# JONES & BEACH ENGINEERS INC.

**RE: Response Letter 3 – TAC Comments  
375 Banfield Road, Portsmouth, NH  
Tax Map 266, Lot 7  
JBE Project No. 19190.2**

We are in receipt of comments from Jillian Harris dated June 1, 2021. Review comments are listed below with our responses in bold.

DRAWING No. **C2**

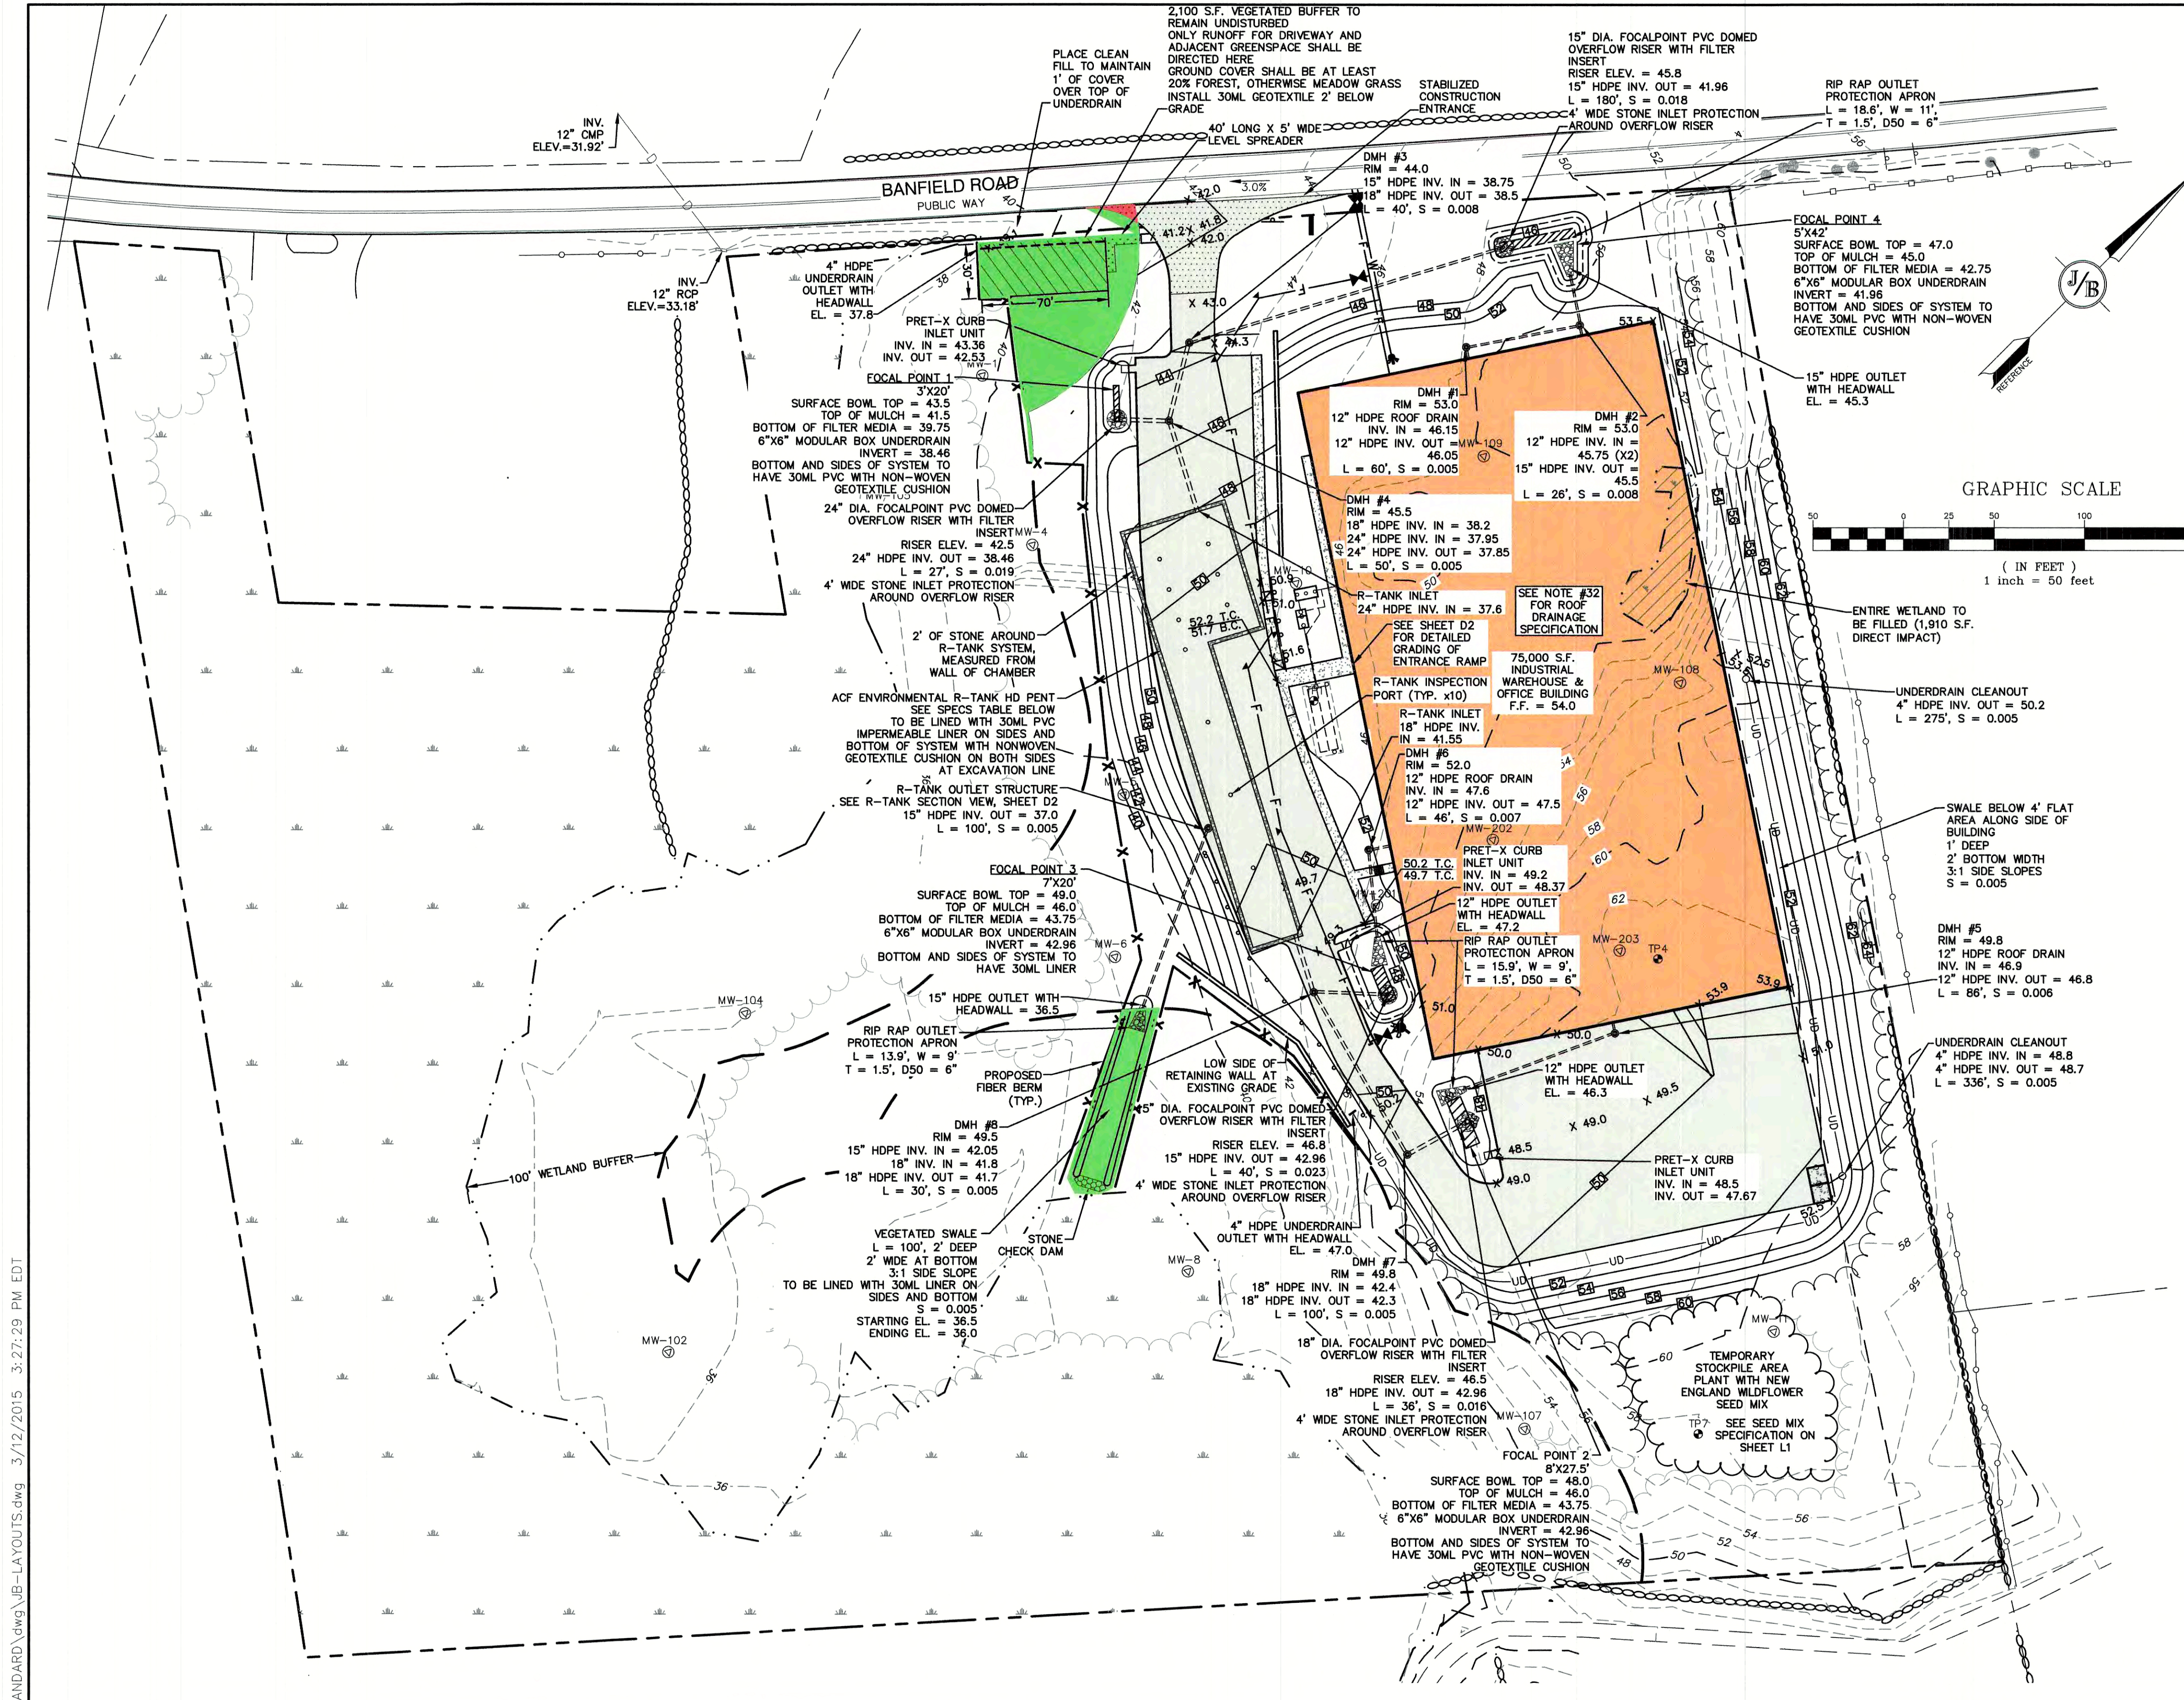
12. *Consideration should be given to add an outdoor seating area for employees either between the parking and the building or between the 100-foot buffer zones adjacent the proposed parking lot.*

**RESPONSE: Note #20 has been added to Sheet C2 discussing the location of the outdoor seating area if the company decides to have one.**

DRAWING No. **L1**  
 SHEET 7 OF 24  
 JBE PROJECT NO. 19190.2

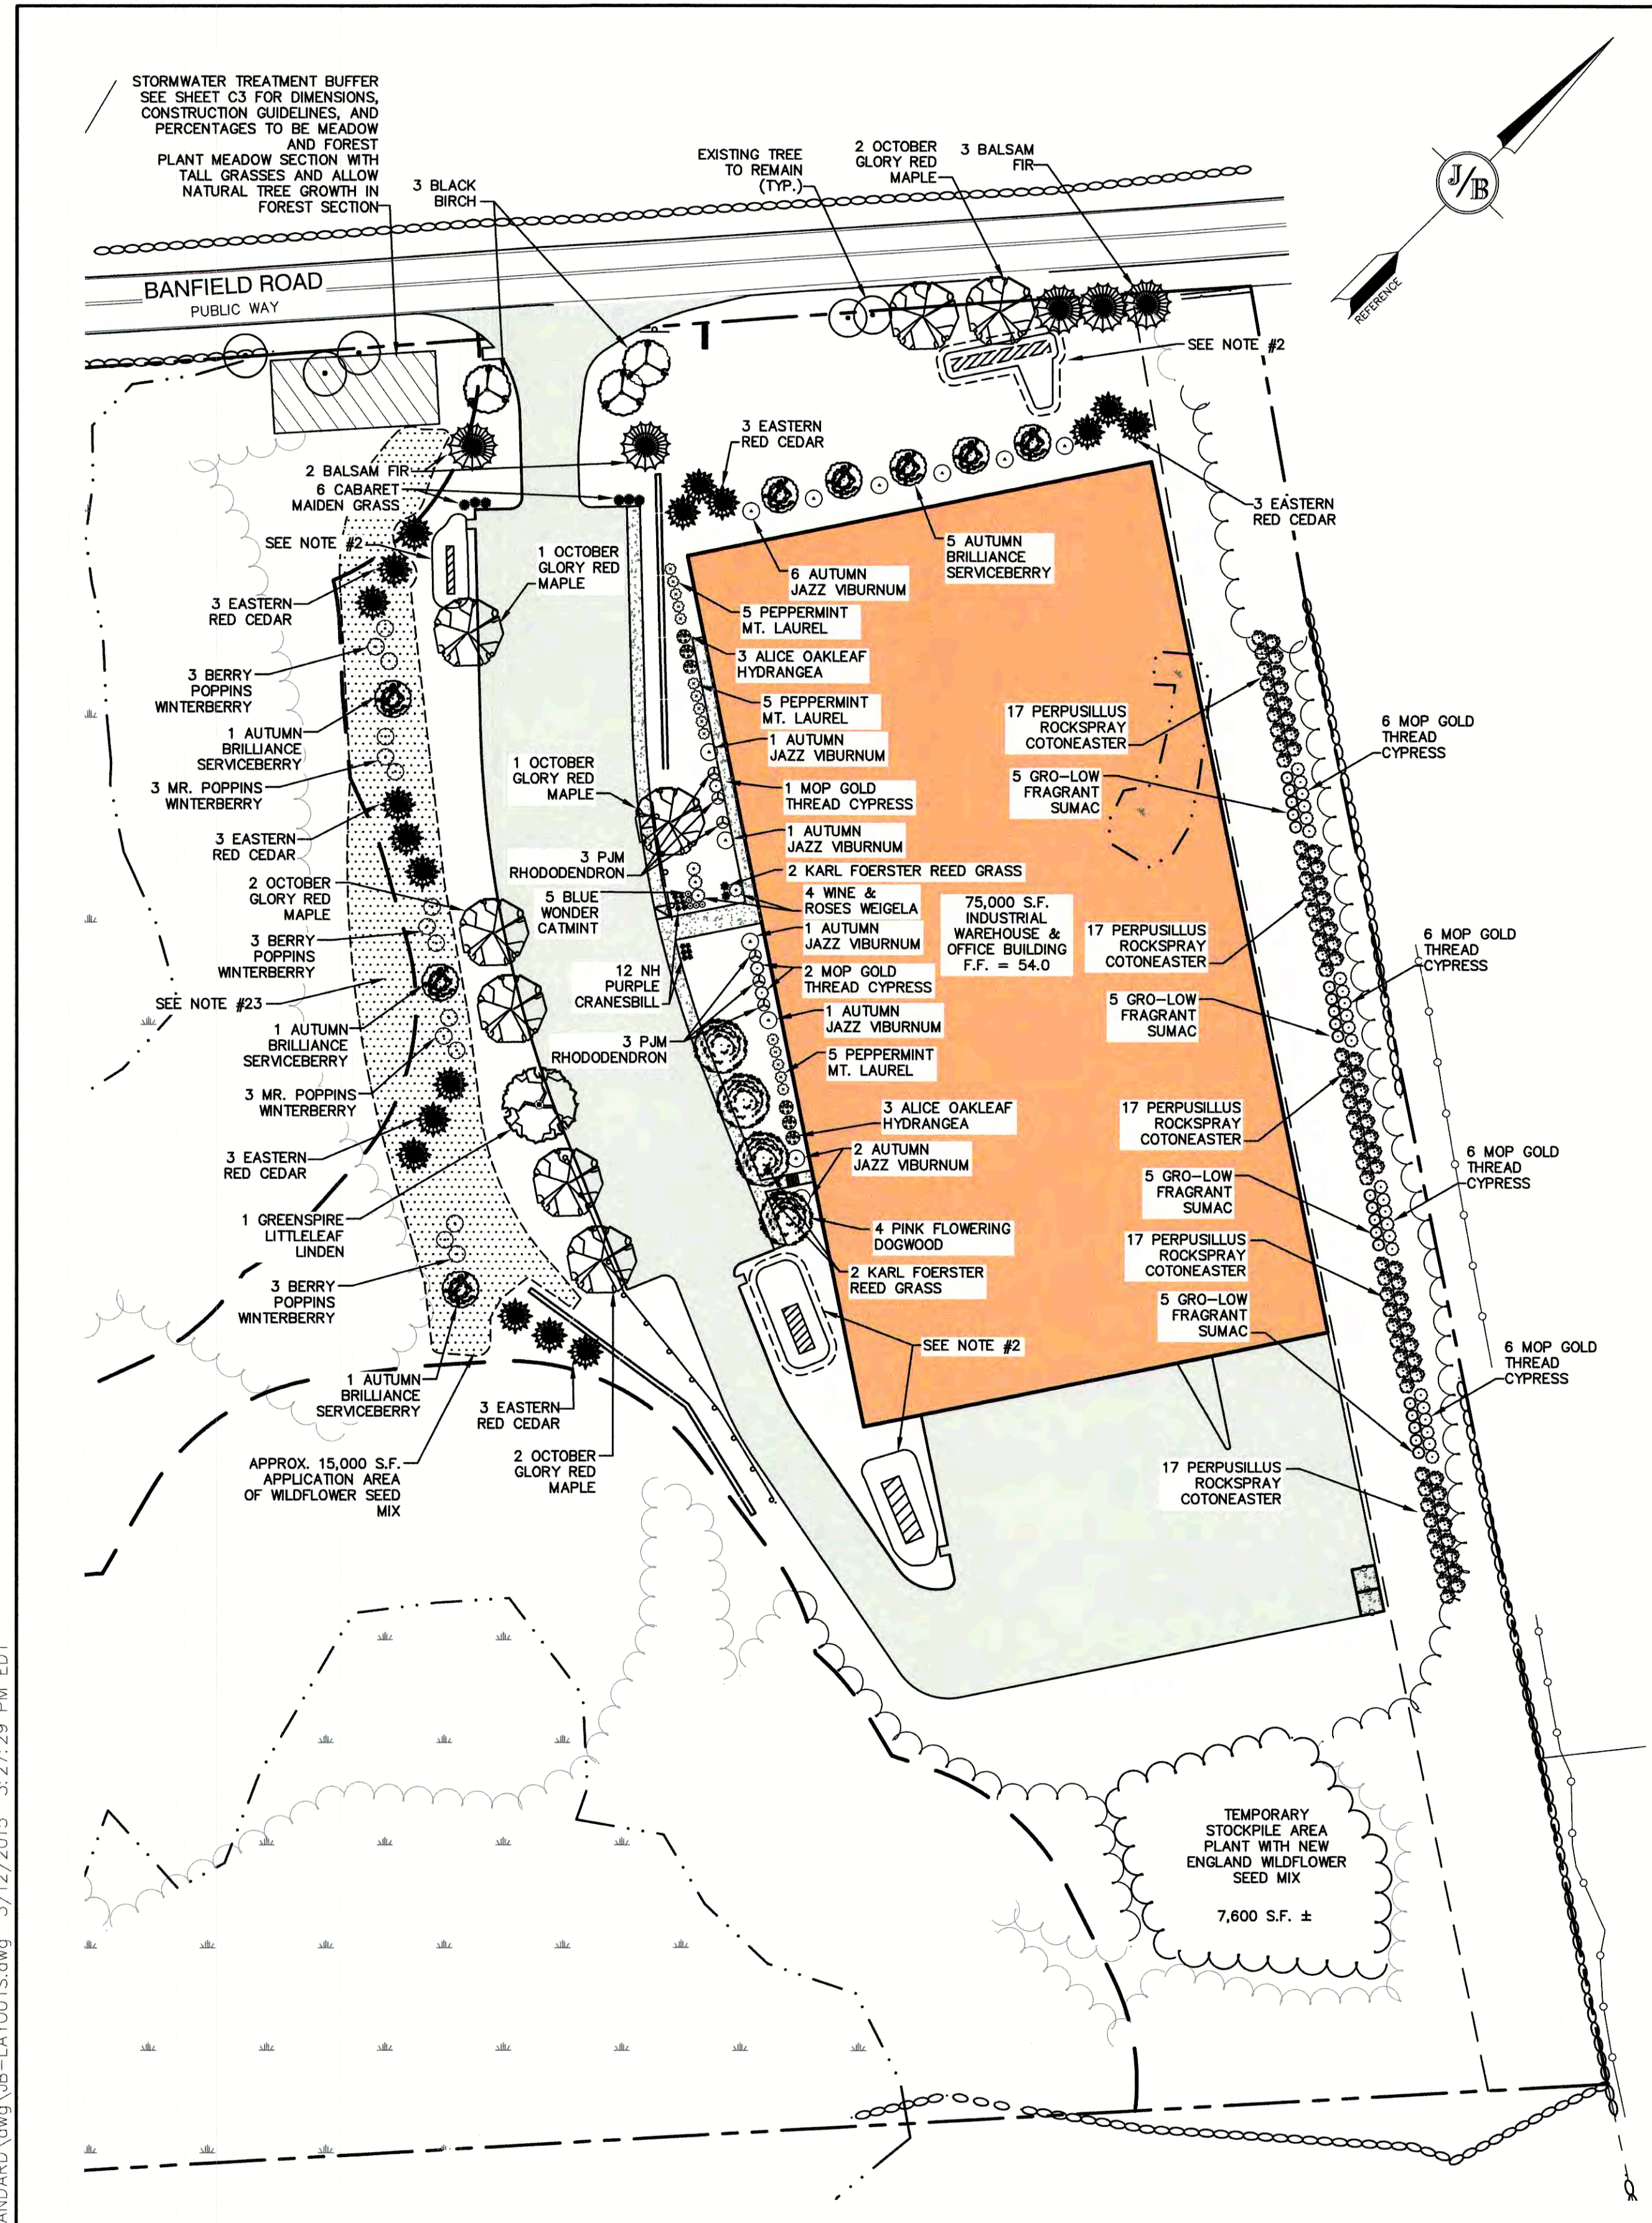
3. *Please verify if you will be using irrigation for any of the proposed landscaping areas.*  
**RESPONSE: It is possible that irrigation will be used, and Note #18 on Sheet L1 states that an irrigation piping system shall be reviewed and approved by the owner and engineer prior to installation.**

10. *All burlap and cages should be removed for landscape plants.*

**RESPONSE:** See Note #22 on Sheet L1.
